## STAFF REPORT

### PLANNING BOARD MEETING

**Case #32-17: SITE PLAN APPROVAL**

100 Duchaine Blvd  
(Map 134, Lot 5)

SHEET 3 OF 9

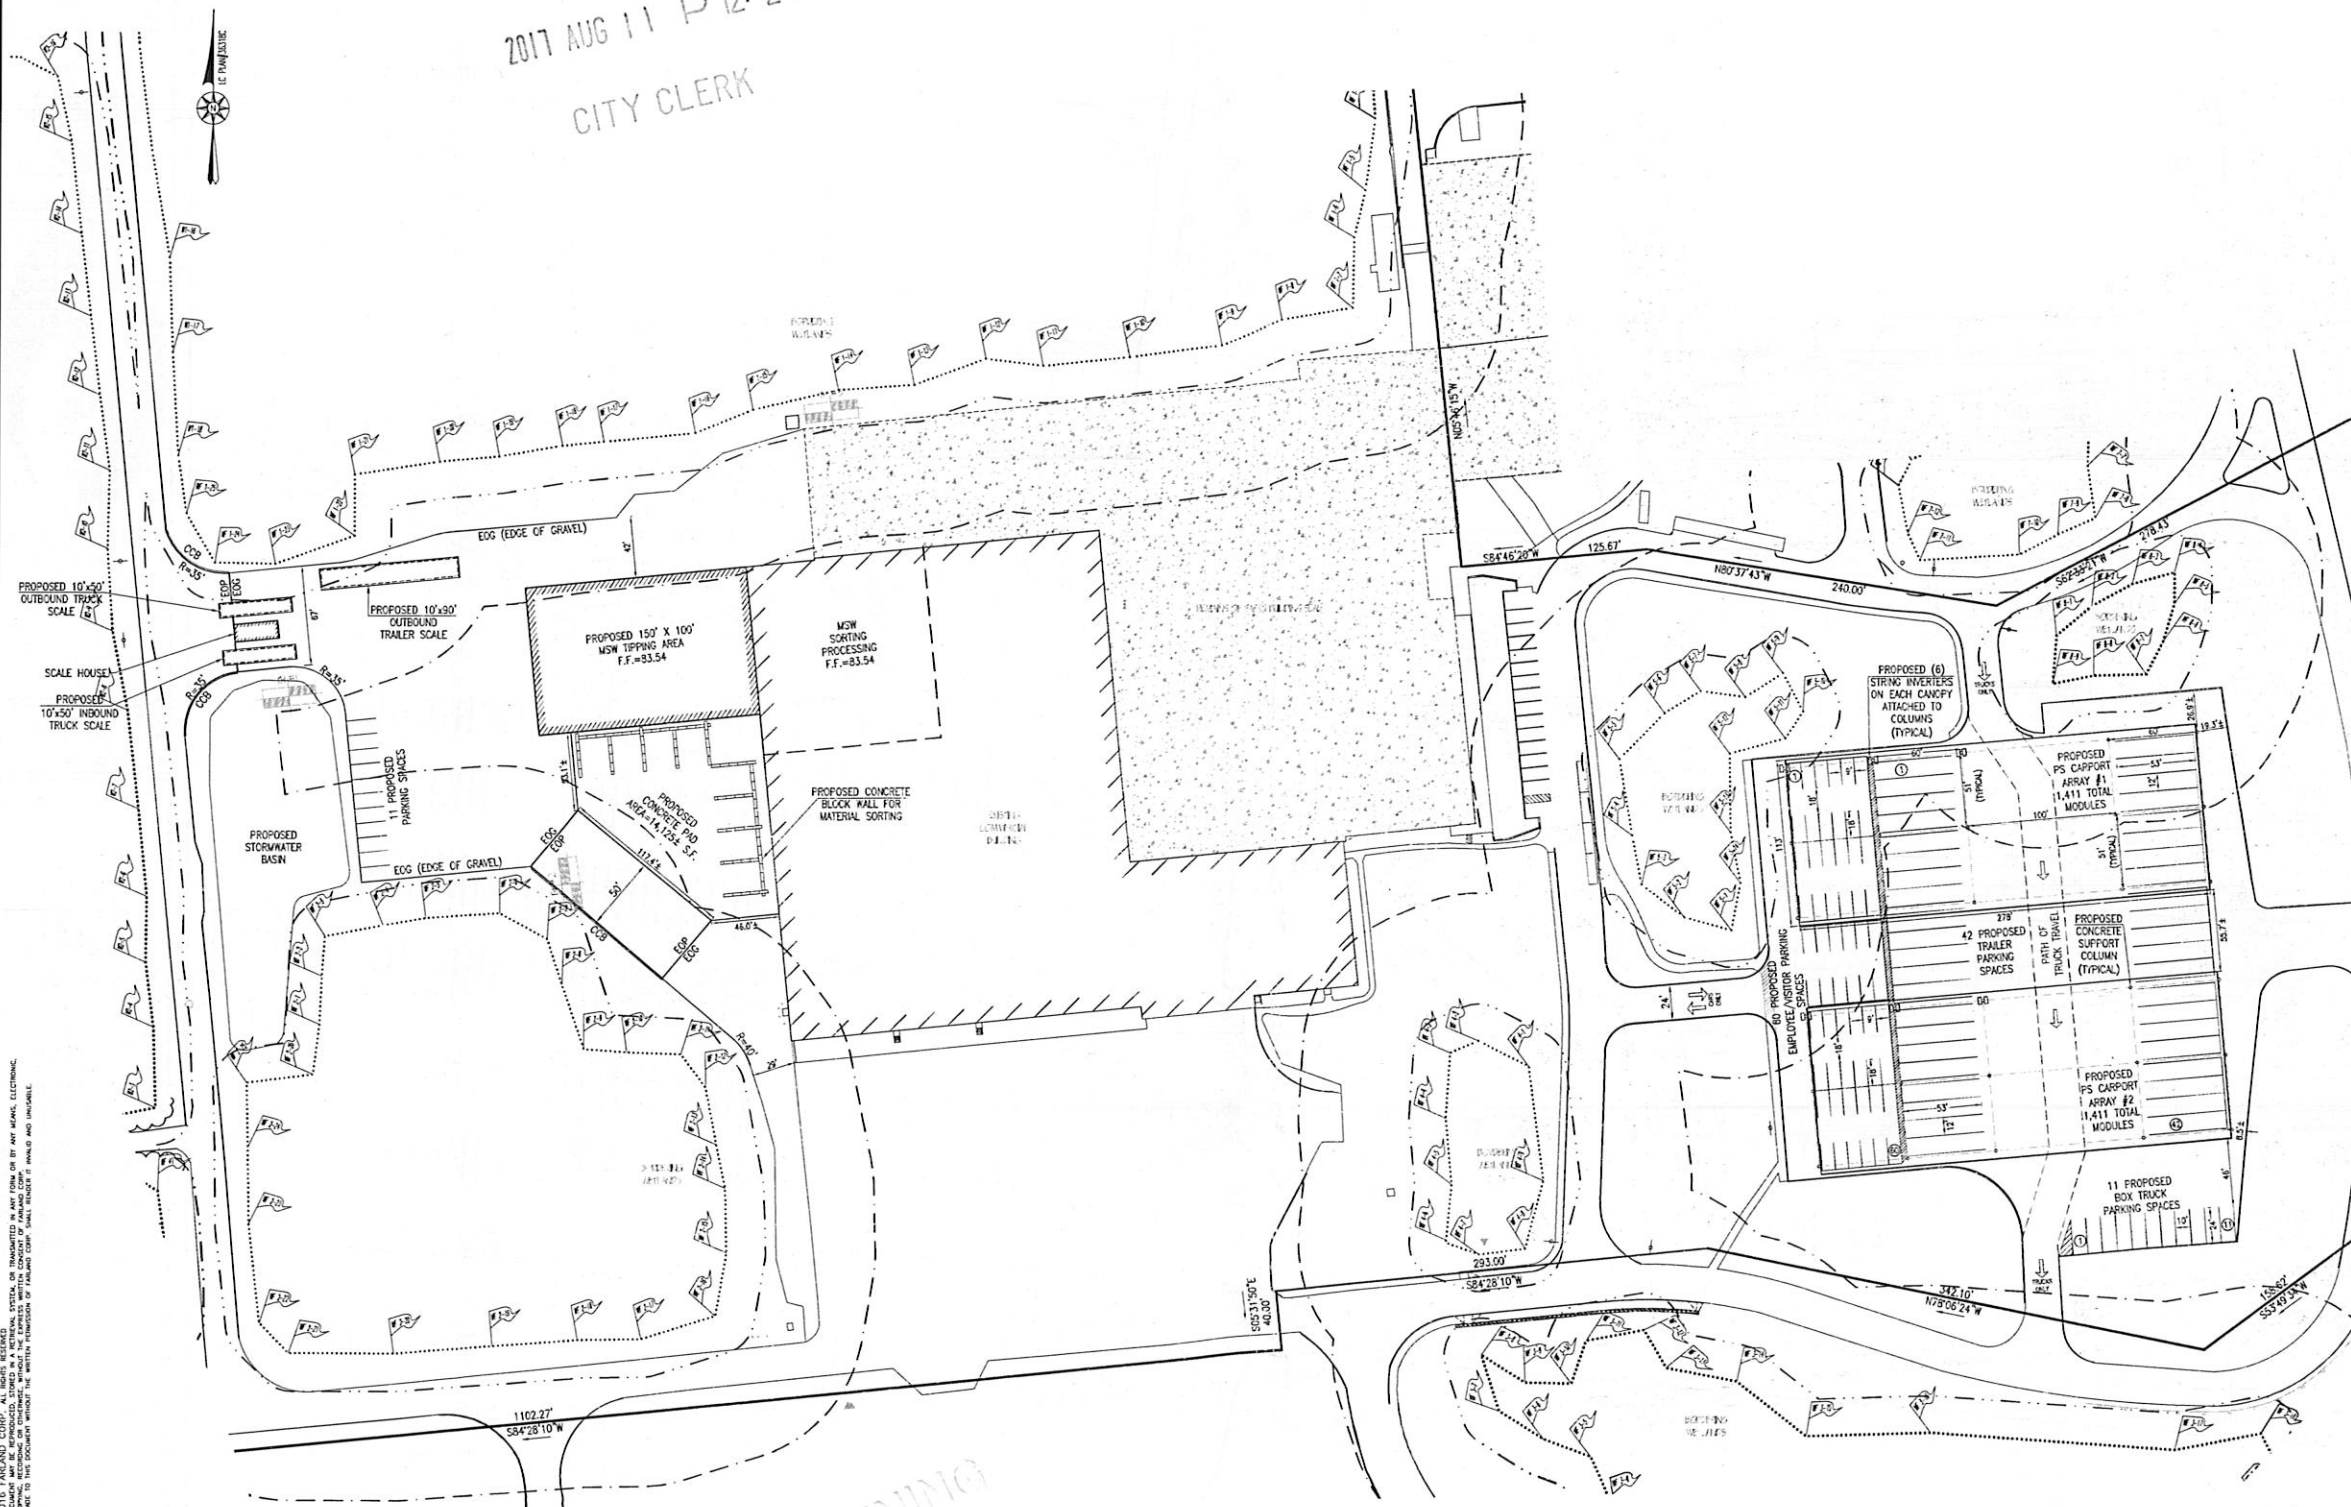
Staff review notes from the Project Summary the applicant is adding 124 spaces to existing parking conditions. Existing Conditions Plan Sheet 3 of 9 shows **303** rectangular 9 foot by 20 foot spaces which include two (2) ADA spaces. Loading docks are not shown on the Existing Conditions plan sheet.

SHEET 4 OF 9

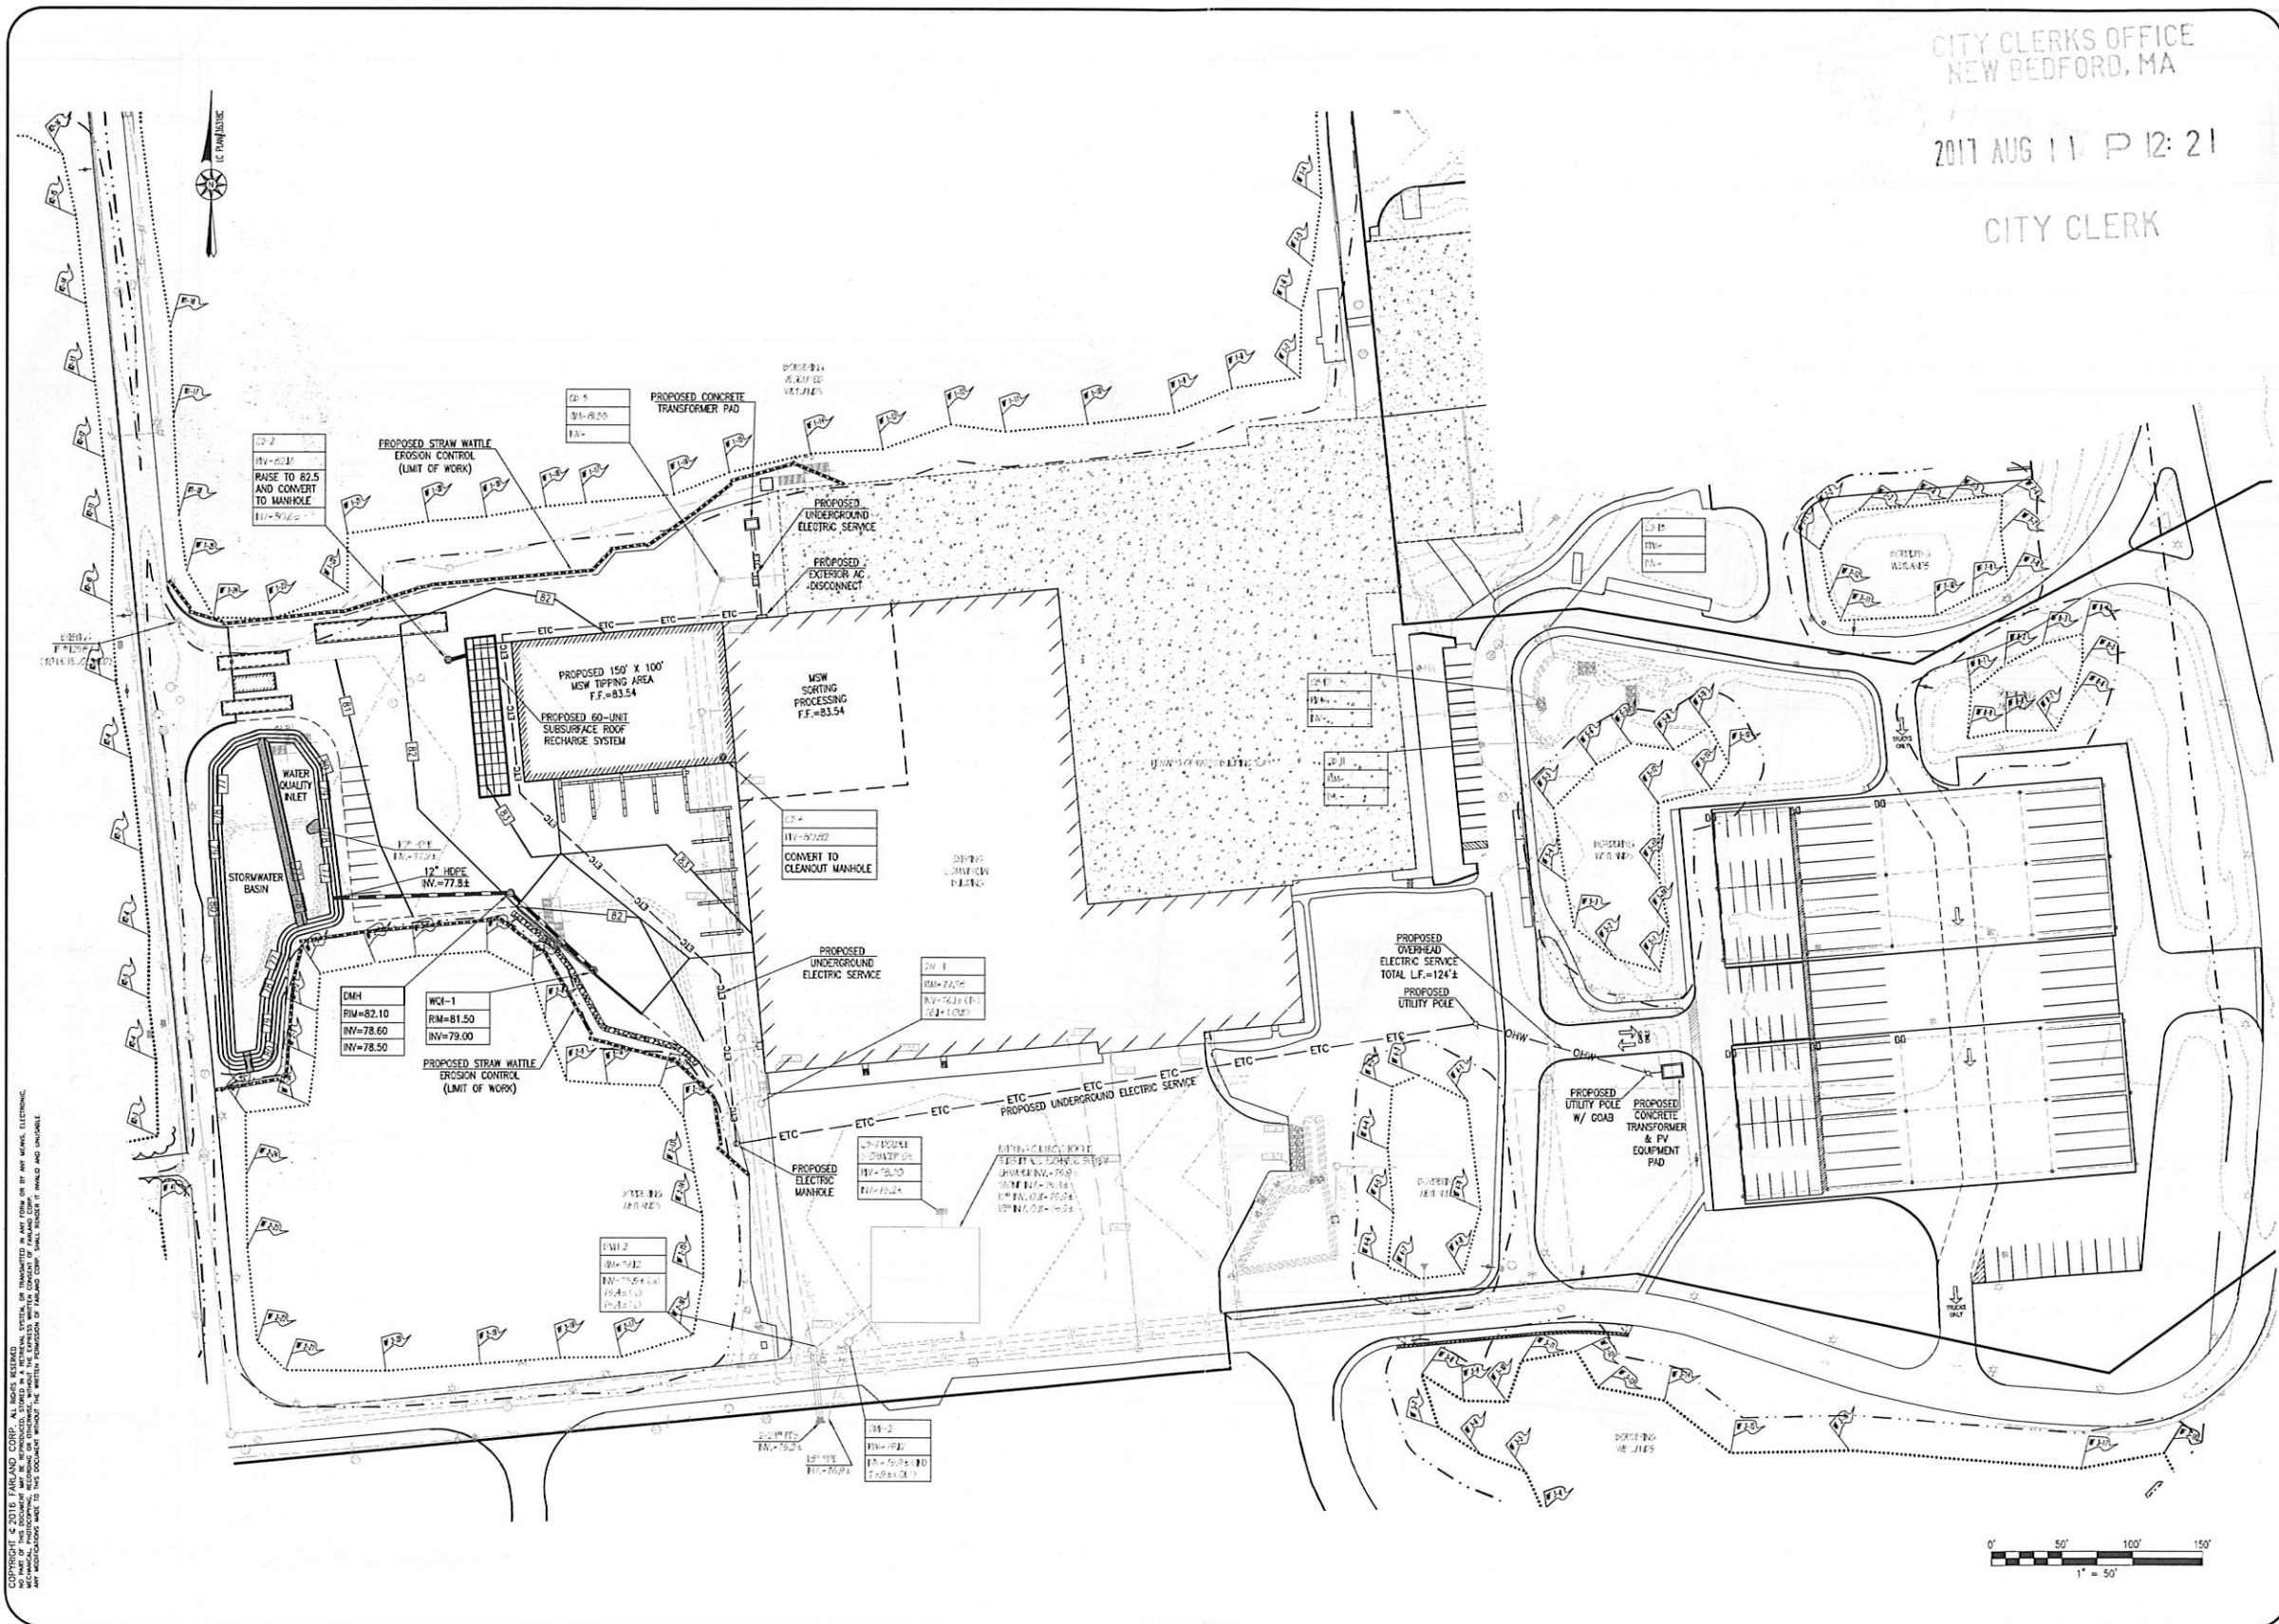
- **Existing Conditions-Sheet 3 of 9**
- **Layout-Sheet 4 of 9**
  - ☐ Identify Snow storage area(s) and snow disposal and plowing plan relative to Wetland Resource Areas.

- ☐ Identify and note curb material for parking area east of existing structure.
- **Utilities & Grading-Sheet 5 of 9**
  - ☐ Staff defers to the Department of Public Infrastructure comments which are forthcoming.

AUGUST 10, 2017  
SCALE: 1"=50'  
JOB NO. 15-500.2  
LATEST REVISION:  
PRE-SUBCATCHMENT  
SHEET 5a OF 9

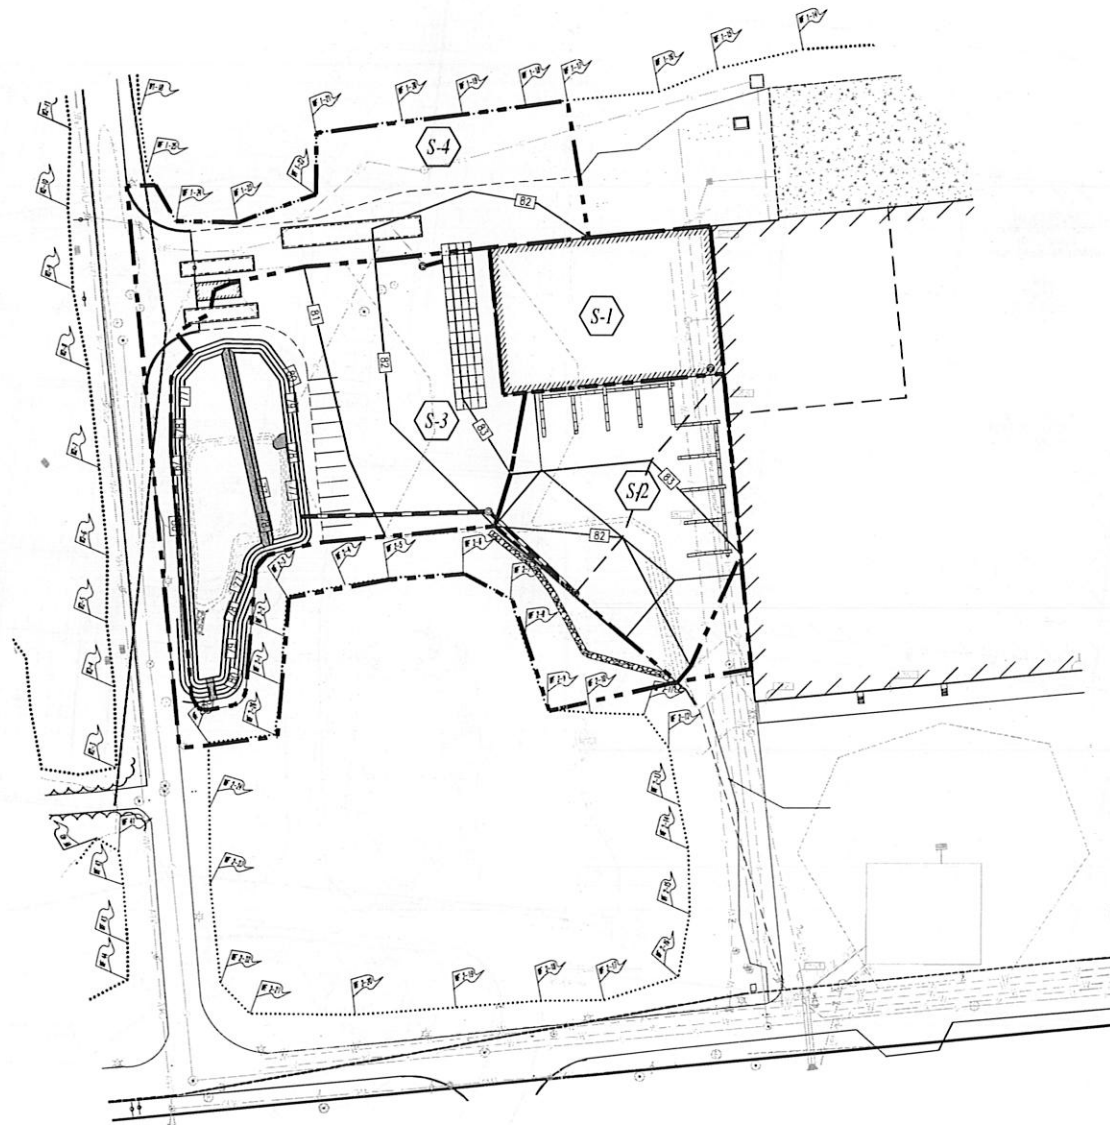
- **Pre-Subcatchment-Sheet 5a of 9**
  - ☐ Staff defers to the Department of Public Infrastructure and Conservation Commission peer review (Attachment 9).

DETAILS  
SHEET 7 OF 9

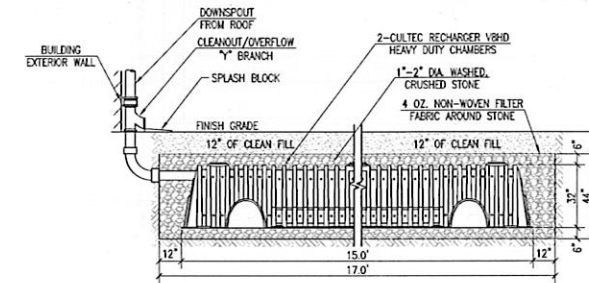
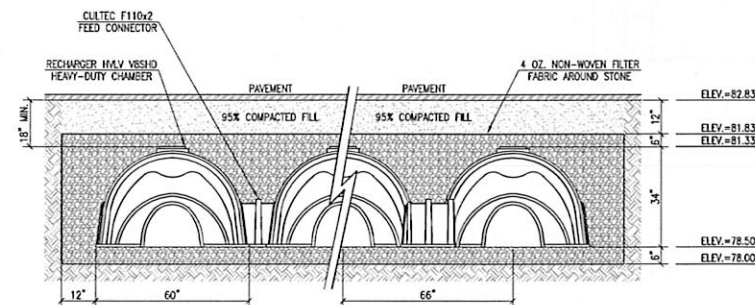
2. The proposed discharge to the existing detention basin should include a flared end and rip-rap pad.
3. The applicant should perform a test hole in the vicinity of the proposed underground infiltration facility to determine seasonal high groundwater elevation and insure that there is two feet of separation between the bottom of the system and seasonal high groundwater. The detail shows seasonal high groundwater elevation as 96.7, which is incorrect.
